Juneau Access Improvements Project Final Supplemental Environmental Impact Statement

2014 Update to Appendix P Anadromous and Resident Fish Streams Technical Report 2017 Errata

2017 ERRATA 2014 Update to Appendix P – Anadromous and Resident Fish Streams Technical Report

Figure 1 Streams in the Project Area

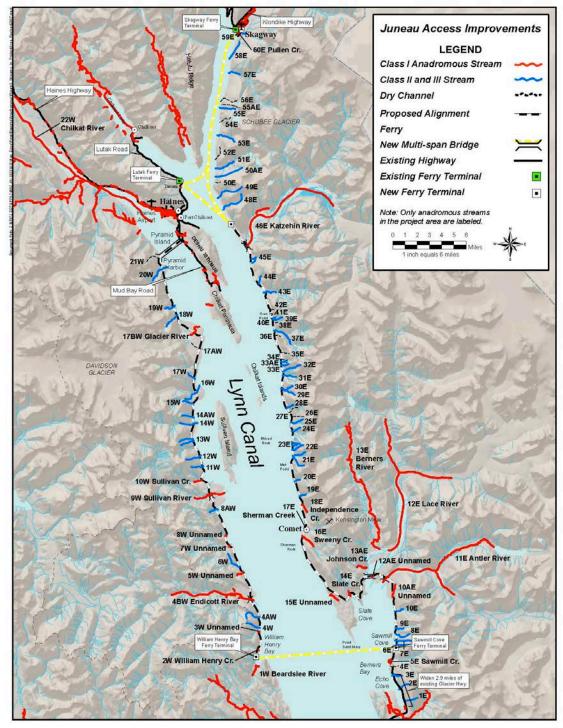
Page, Section	Reads	Should Read (changes shown)
Page B-1, Attachment B, Updated Figures.	 Text on page B-1 should be replaced with the following: Figure 1, Streams in the Project Area, is a revised version of Figure 1 in the 2014 Update to Appendix P - Anadromous and Resident Fish Streams Technical Report. Below are revisions included in Figure 1: 47E, unnamed stream, is no longer listed as an anadromous stream. The stream has been reclassified as a "Class II and III Stream." 17E, Sherman Creek, configuration has been modified. The extent of stream listed as anadromous is decreased. 13E, Berners River, configuration has been modified. The extent of stream listed as anadromous is decreased. 5E, Sawmill Creek, configuration has been modified. The extent of stream listed as anadromous is decreased. 5E, Sawmill Creek, configuration has been modified. The extent of stream listed as anadromous is decreased. 3W, unnamed stream, configuration has been modified. The extent of stream listed as anadromous is decreased. 3W, unnamed stream, configuration has been modified. The extent of stream listed as anadromous is decreased. 3W, unnamed stream, configuration has been modified. The extent of stream listed as anadromous is decreased. 3W, unnamed stream, configuration has been modified. The extent of stream listed as anadromous is decreased. 3W, unnamed stream, configuration has been modified. The extent of stream listed as anadromous is decreased. 3W, unnamed stream, configuration has been modified. The extent of stream listed as anadromous is decreased. 3W, unnamed stream, configuration has been modified. The extent of stream listed as anadromous is decreased. 3W, unnamed stream, configuration has been modified. The extent of stream listed as anadromous is decreased. 9AW, Sullivan River, configuration has been modified. The extent of stream listed as anadromous is decreased.

Page B-2, Attachment B (Updated Figures), Figure 1	Figure 1, Streams in the Project Area, is replaced with the attached updated figure.
